Great Western Highway Upgrade Medlow Bath

Submissions Report

Transport for NSW | June 2022

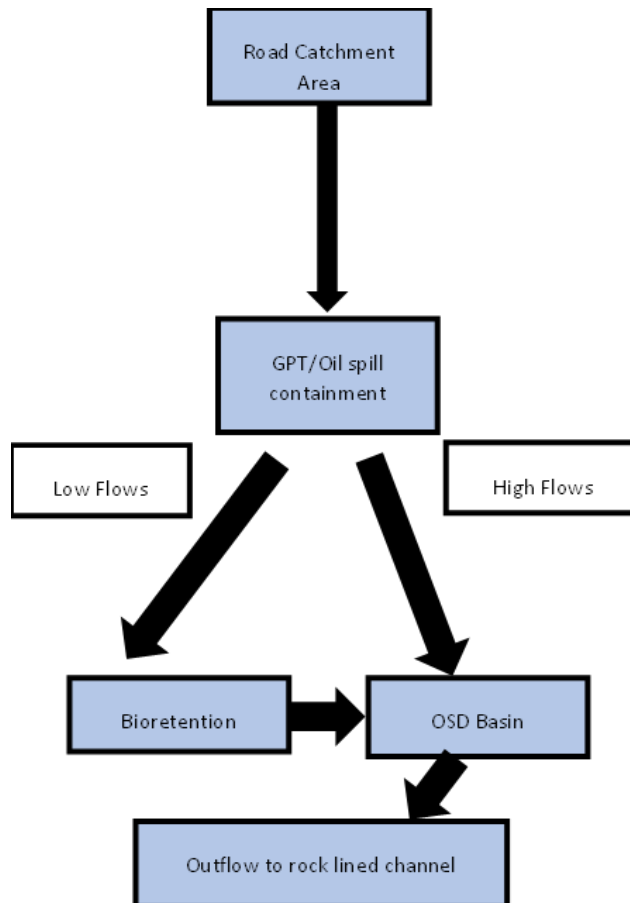
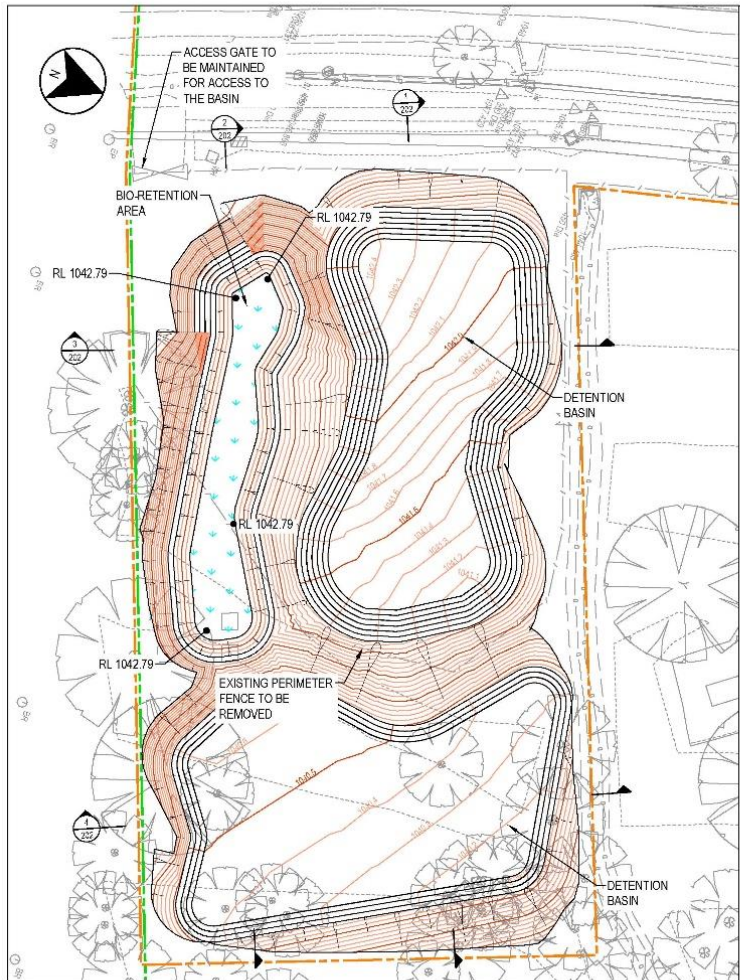
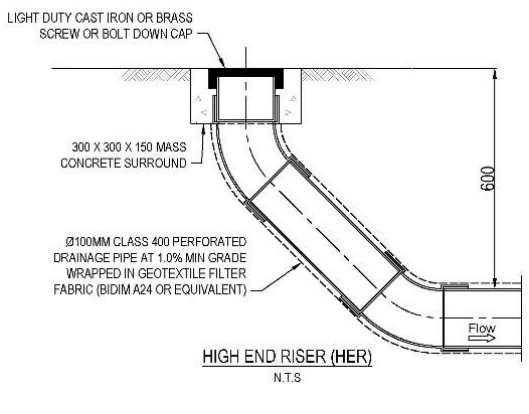
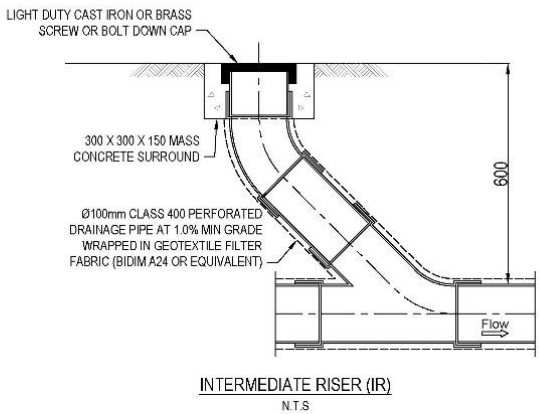
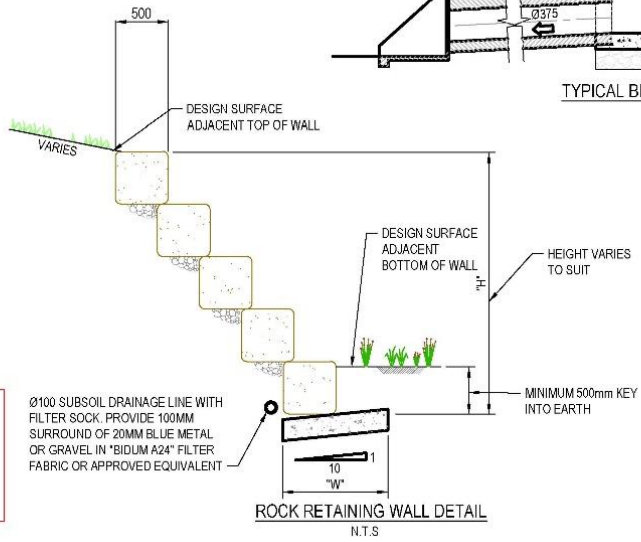
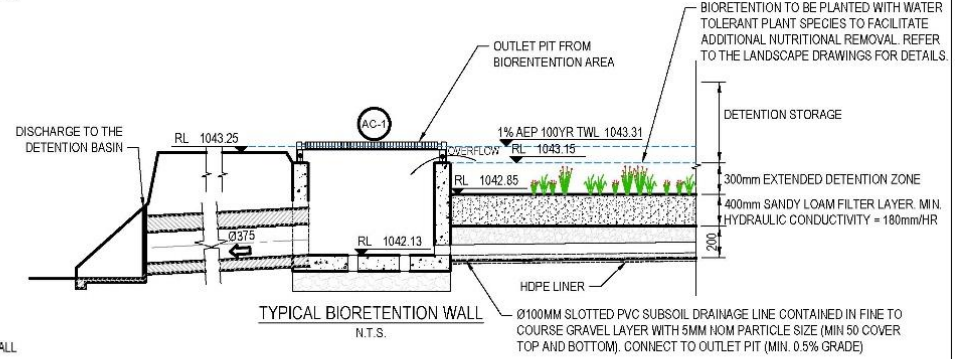
- The REF does not provide a detailed assessment of the identified threatened swamp communities and any potential impacts from stormwater discharges or proposed mitigation measures to address these impacts. Stormwater impacts should be represented visually by showing stormwater discharge locations in reference to the identified swamp locations.

The proposed detention basin is located on the eastern side of the rail alignment south of Medlow Park. This basin will capture the water from the northern sections of the Great Western Highway and Railway Parade. Its outflows will discharge into the existing rock lined channel in the park (as described in the REF). The catchment for Medlow Bath is isolated to the project area with only a small volume of water discharged to the neighbouring catchment. Mitigation measures will capture and treat the stormwater discharging to the adjacent area during construction and interim operation, and operational management will be detailed in the adjoining works package.

The design of the water basin in Medlow Park has been refined since the REF was issued in July 2021, including the following refinements:

- The sizing of the basin has been completed based on capture runoff from the proposed road upgrade works, rail corridor areas and upstream catchments of the road alignment

- The basin design has been updated to include two separate storage areas with a pipe provided between them to reduce the overall depth of the basin, facilitating an 'open to public' park design. The design of the sediment basin accounted for 1% AEP storm events and includes allowance for climate change.

- Bioretention system incorporated within the onsite detention basin to treat the water prior to discharge. The bioretention basin contains water tolerant plant species to facilitate nutrient removal. This is achieved by sediments and attached pollutants (including nutrients, metals, and other soluble pollutants) being removed via filtration through the vegetative surface layer and filter media below; and

- In addition to biofiltration areas, groundwater penetration will be encouraged through detention basin design which will promote natural filtration within the detention area. The dry basin will be planted out in a manner to prevent ingress of noxious weeds. It will be surrounded by sandstone block edgings to minimise the use of concrete and gabion basket devices, which will reduce maintenance and debris build up that can reduce the effectiveness of the basin system.

Further details of design of the detention basin developed in partnership with Blue Mountains City Council and WaterNSW is on the following page and within Appendix 7. An assessment of potential cumulative impact can be found in Appendix 8.
